# Service Bulletin

Category S	Applicable Model/s 1988-'91 626/MX-6	Subject POWER DOOR LOCKS MALFUNCTION	Bulletin No. 018/91 Issued 11/22/91 Revised
---------------	--	---	---

**Figure 1: Power Door Lock Switch  
(Driver's Door)**

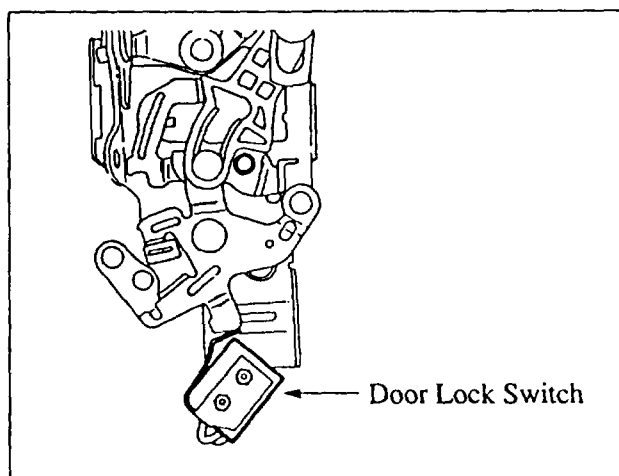
1. Inspect switch. See Section 14 or S of the Workshop Manual.
2. If necessary, replace the driver's door lock switch. See Workshop Manual for replacement procedures. **Figure 1.**

The modified parts are not interchangeable with the original parts. Refer to the VIN and Parts Information for correct model-to-parts application.

**Figure 2: Applying Adhesive to Switch**

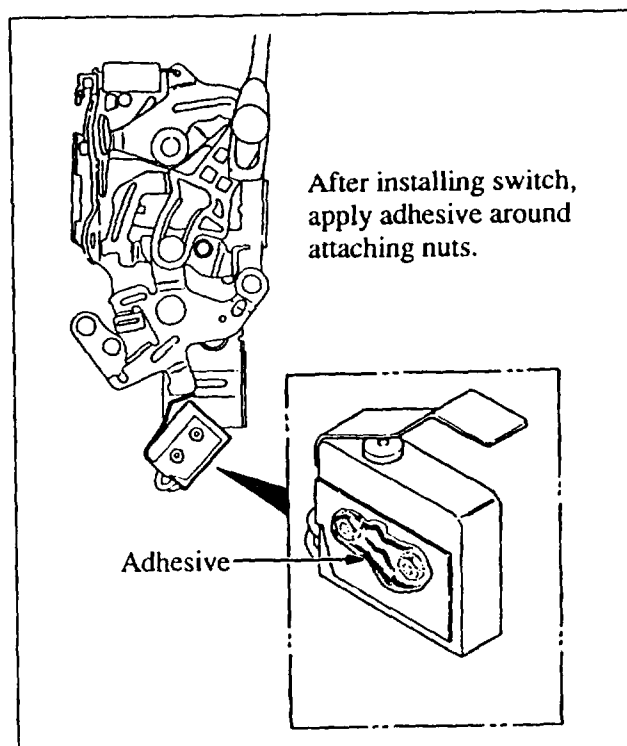
3. Using Three-Bond Synthetic Rubber-Type Adhesive (1521) or equivalent (silicon sealer), apply adhesive around the attaching nuts. **Figure 2.**
4. Allow adhesive to dry for about 10 minutes. Install the door lock mechanism and the door panel.
